Handbook of Human Reliability Analysis with Emphasis on Nuclear Power Plant Applications

Addendum #1 to NUREG/CR-1278, August 1983

Following are some corrections to the above document, listing the page (p) and paragraph (para) numbers. Understandable typos are excluded. Some updating of references is included.

Figure 12-3 Initial-screening model of estimated HEPs and UCBs for diagnosis within time T of one abnormal event by control room personnel (based on Oswald et al, 1982).

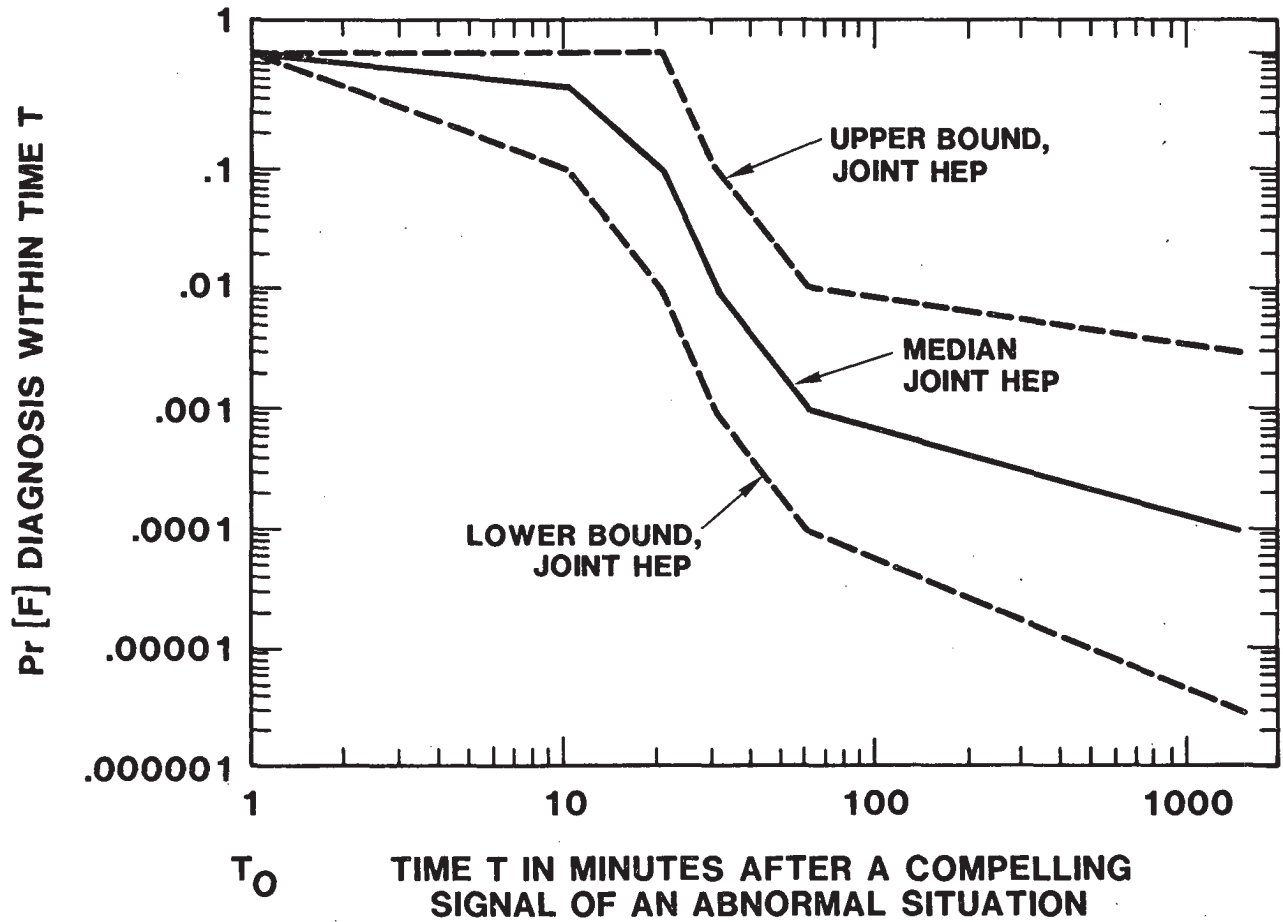
- 12-8,4 Line 7: ... emergency operating procedures ...
- 12-12,3 Line 4 & 5: ... Wreathall (1981, p 104, and 1982), ...
- 12-13 Table 12-3: The 3 lines in the figure should meet at the 1.0 Pr[F] rather than at the .9 HEP. Also, the 1 (e.g., HEP of 1.0) is incorrectly placed; it should be in the same relative position above the .9 HEP as is the .1 HEP above the .09 HEP. The Pr[F] values for the lower bound and median HEPs at 10 minutes are correct. The Pr[F] values for the upper bound HEP at 20 minutes should be 1.0.

Figure 12-4 Nominal model of estimated HEPs and UCBs for diagnosis within time T of one abnormal event by control room personnel.

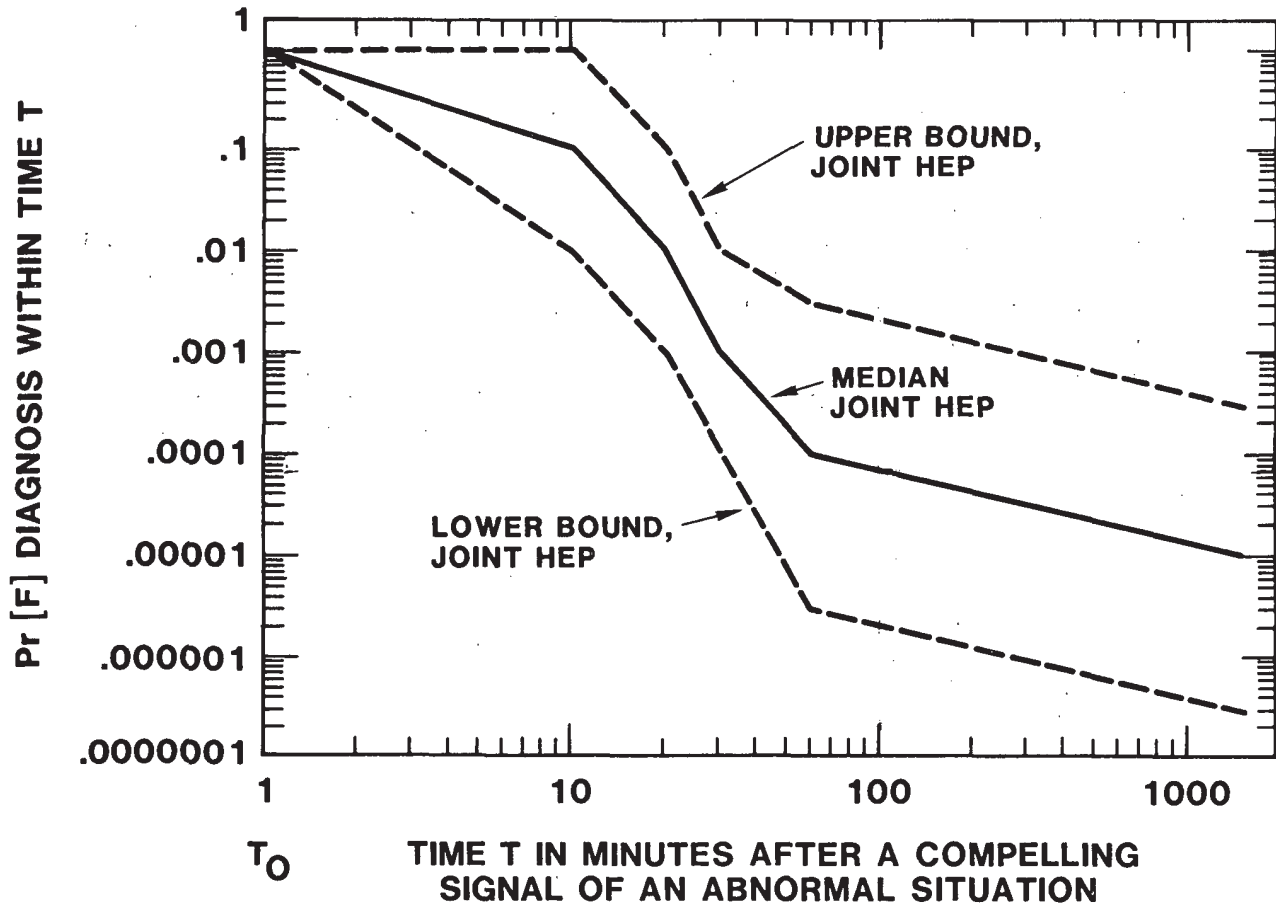
- 12-20 Table 12-4: The 3 lines in the figure should meet at the 1.0 Pr[F] rather than at the .9 HEP. Also, the 1 (e.g., HEP of 1.0) is incorrectly placed; it should be in the same relative position above the .9 HEP as is the .1 HEP above the .09 HEP. The Pr[F] values for the lower bound and median HEPs at 10 minutes are correct. The Pr[F] values for the upper bound HEP at 10 minutes should be 1.0.

Figure 20-1 Search scheme for use of Chapter 20 tables (p 1 of 3).

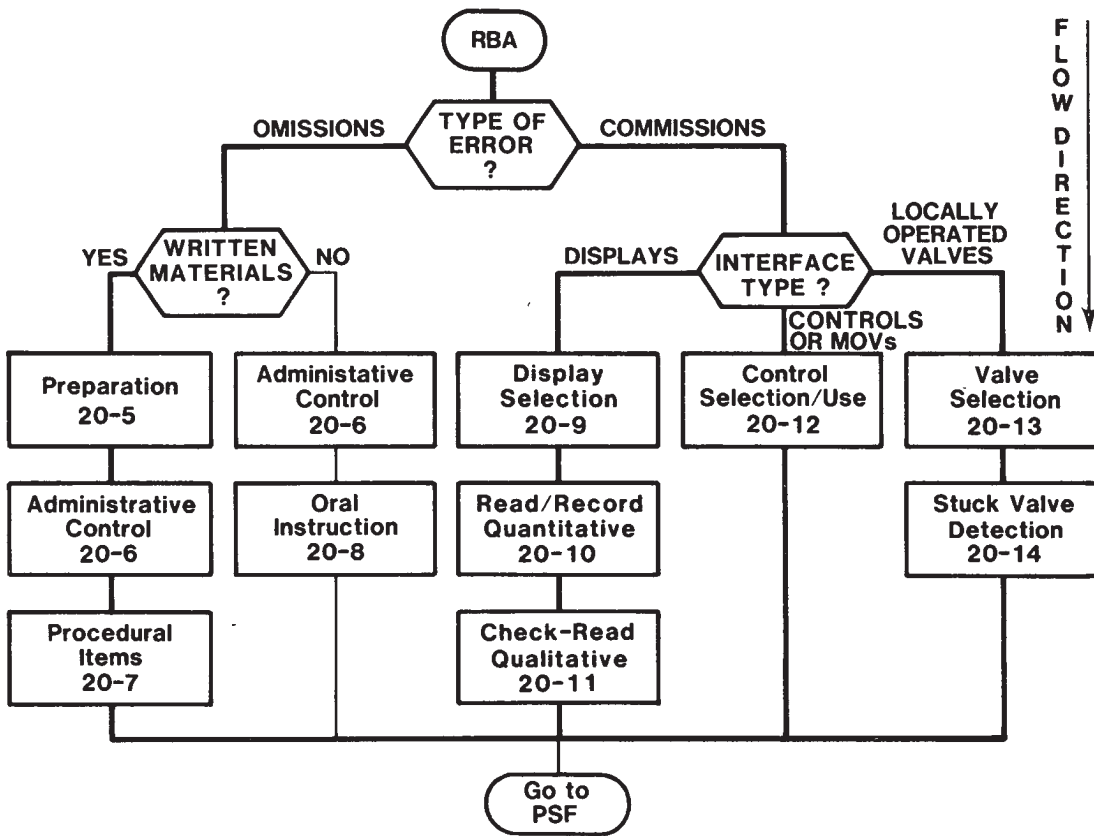
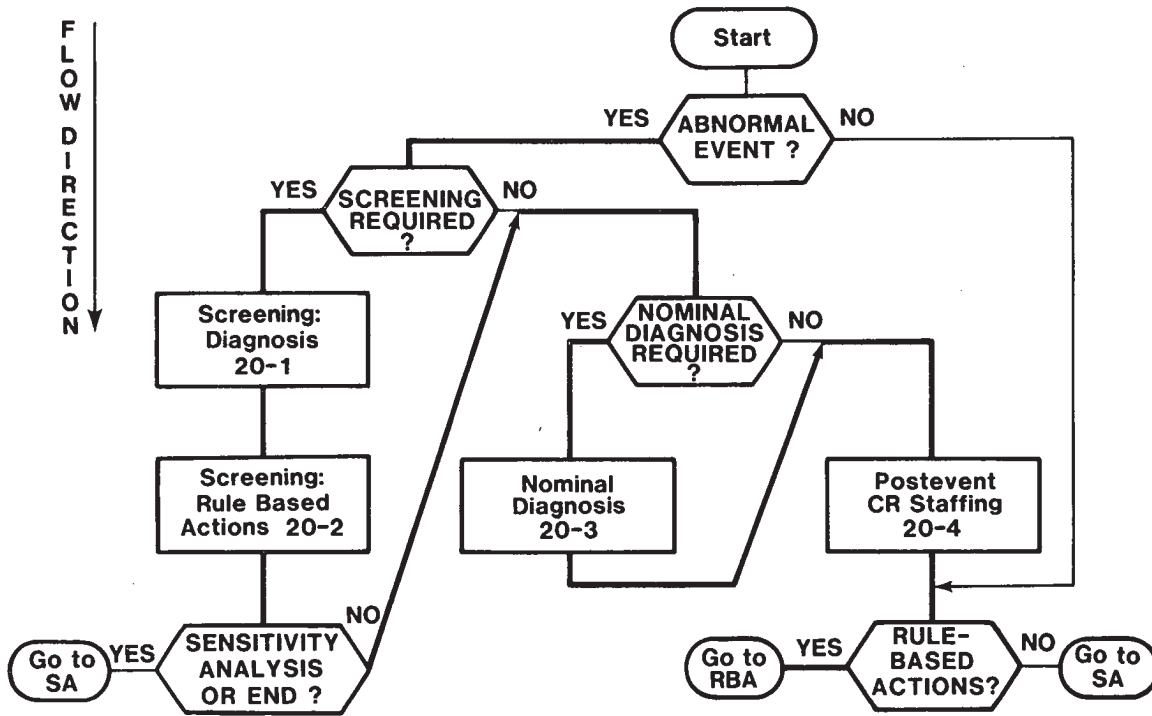
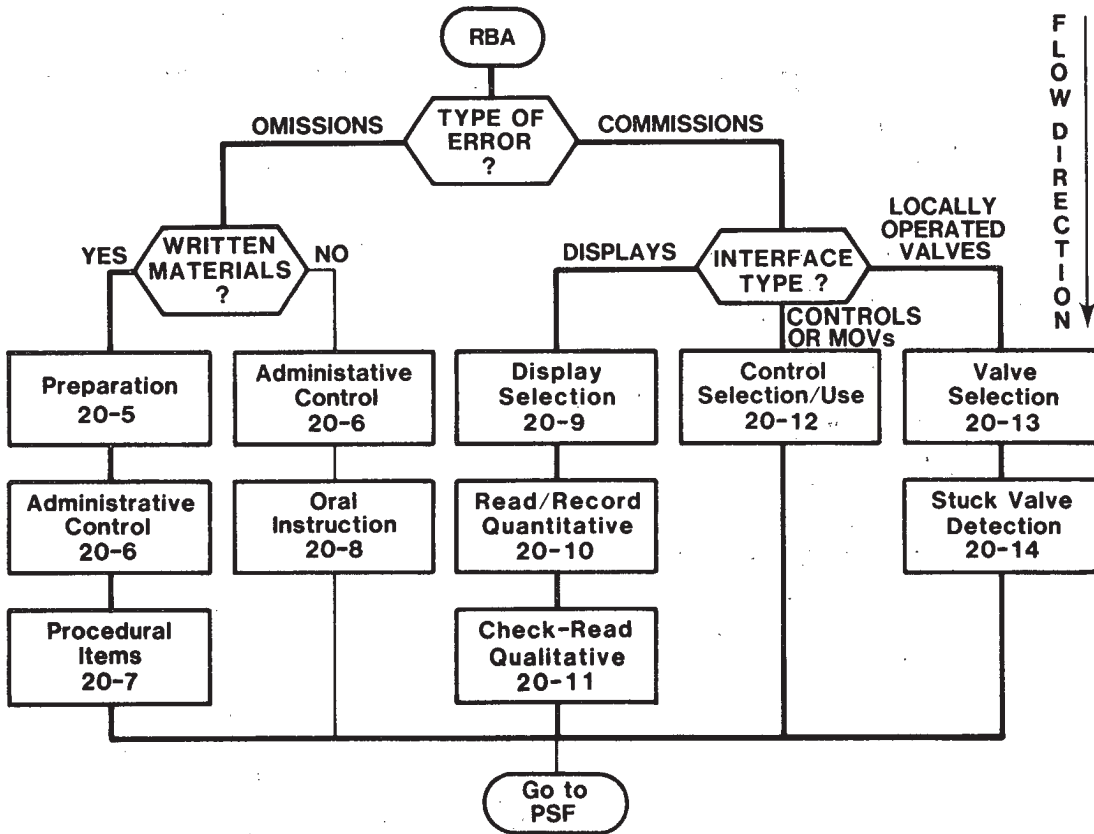
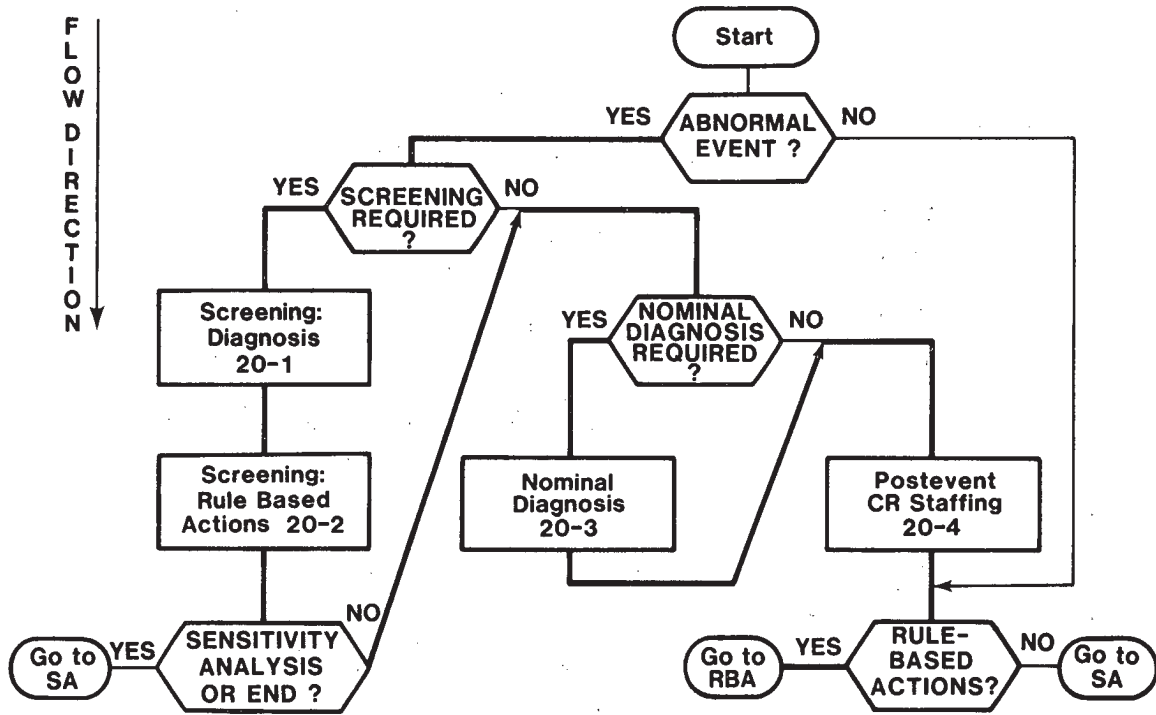
- 20-3 Figure 20-1 (p1 of 3): Insert a "Screening Required?" hexagon in the No line following the "Abnormal Event?" hexagon. The YES and NO lines from the new hexagon go to the "Rule-Based Actions?" hexagon. Insert a "Decide on Screening Rules" box in the YES line.
[This change is necessary because many PRAs require some form of screening for pre-accident situations.]

Figure 20-1 Search scheme for use of Chapter 20 tables (p 2 of 3).

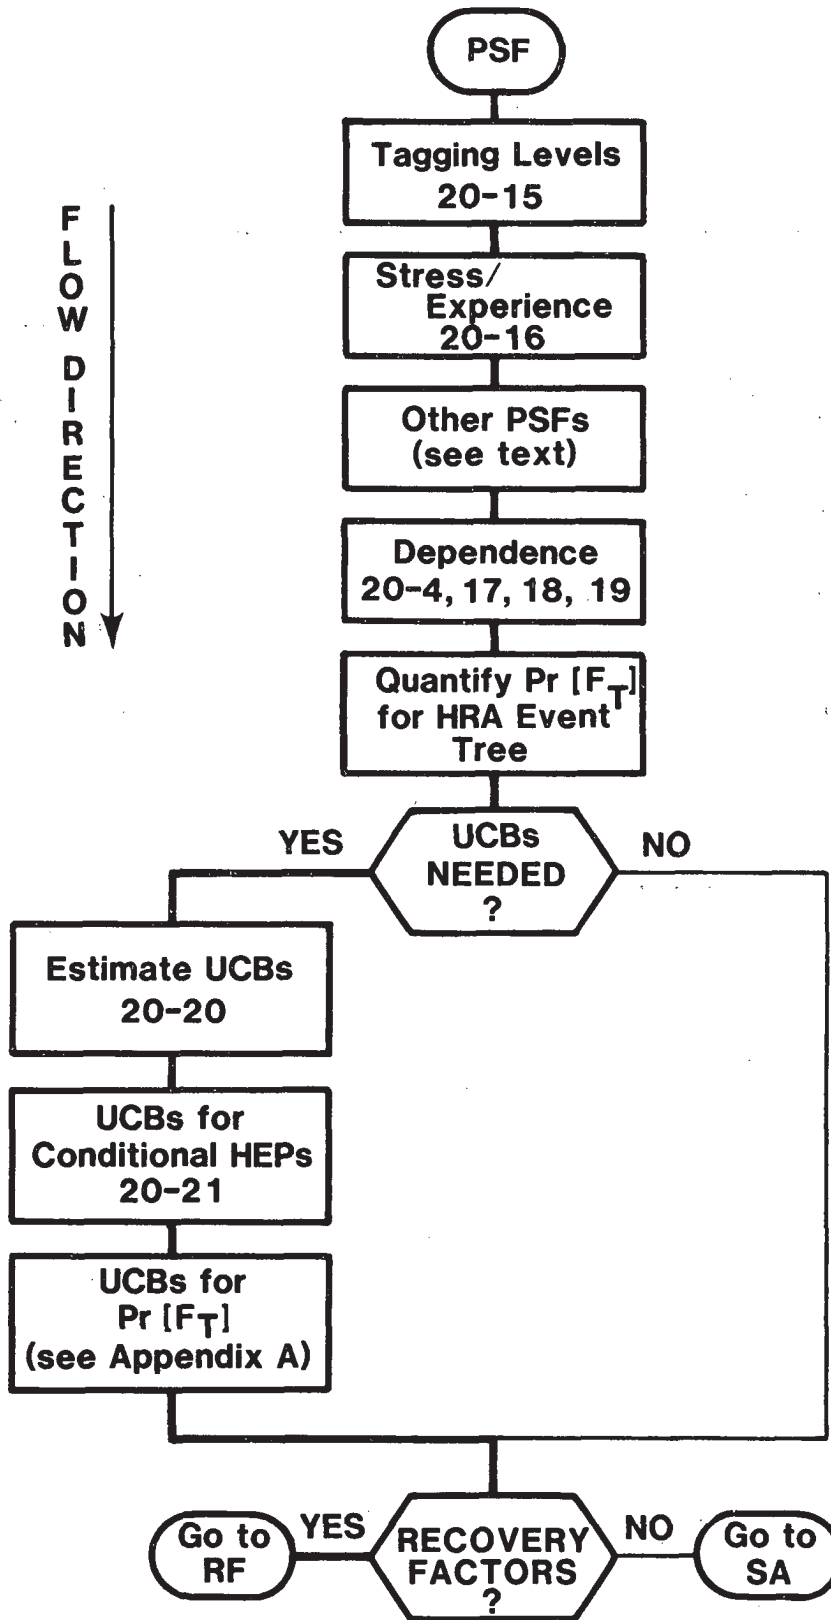
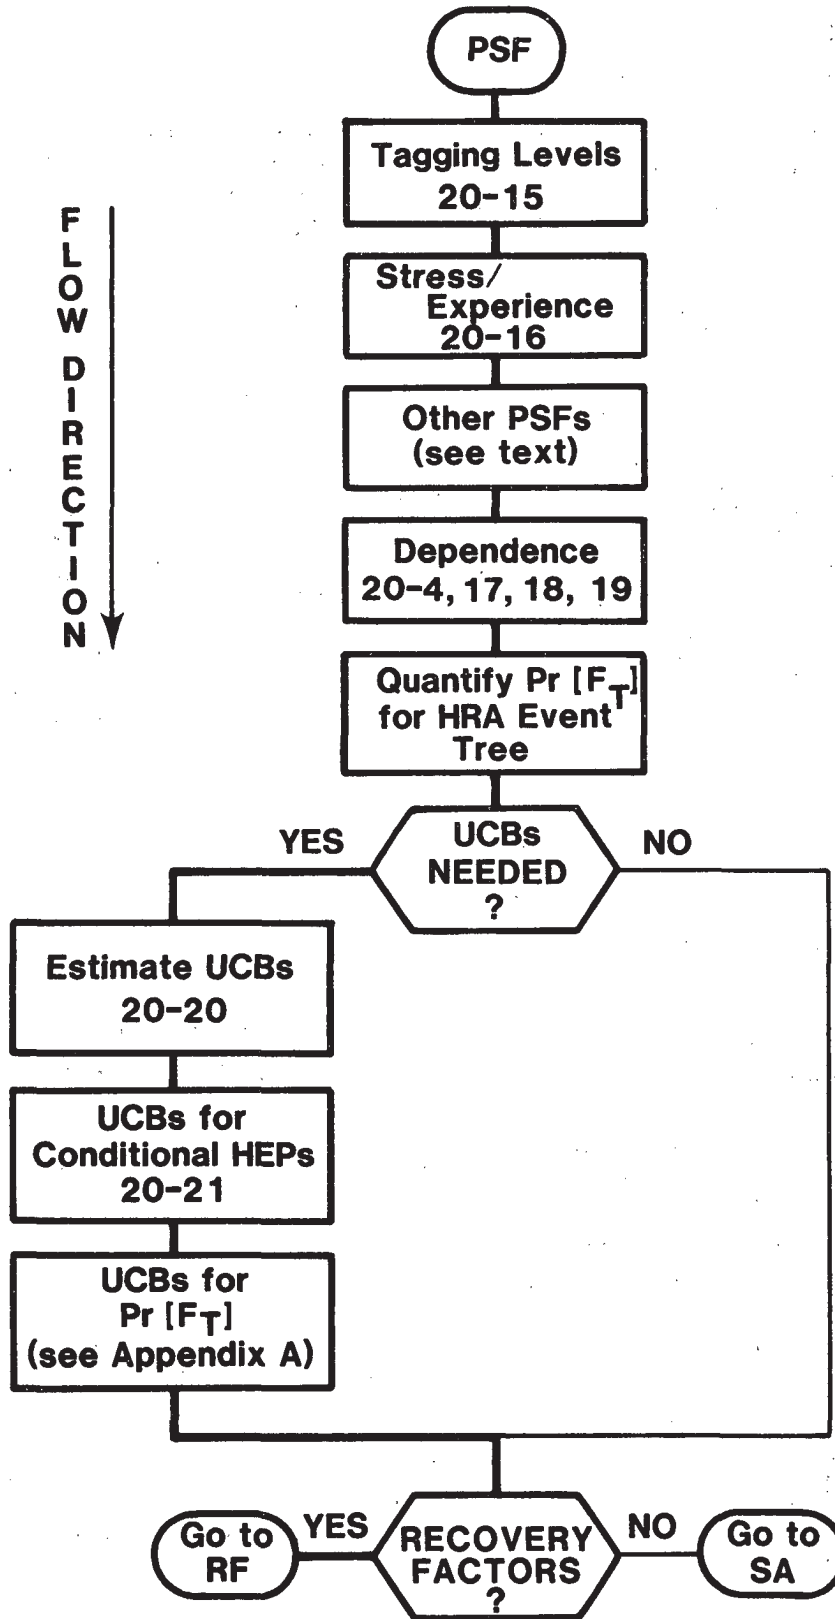
- 20-4 Figure 20-1 (p2 of 3), "Other PSFs" box: Other PSFs (see text, especially pp 3-14, -17,- 19,- 72, and 17-7)
- 20-6,5 Item (2), line 7: ... Assume YES. (Note: Screening may also be required for non-abnormal tasks, as shown in the NO path following the ABNORMAL EVENT? hexagon.)
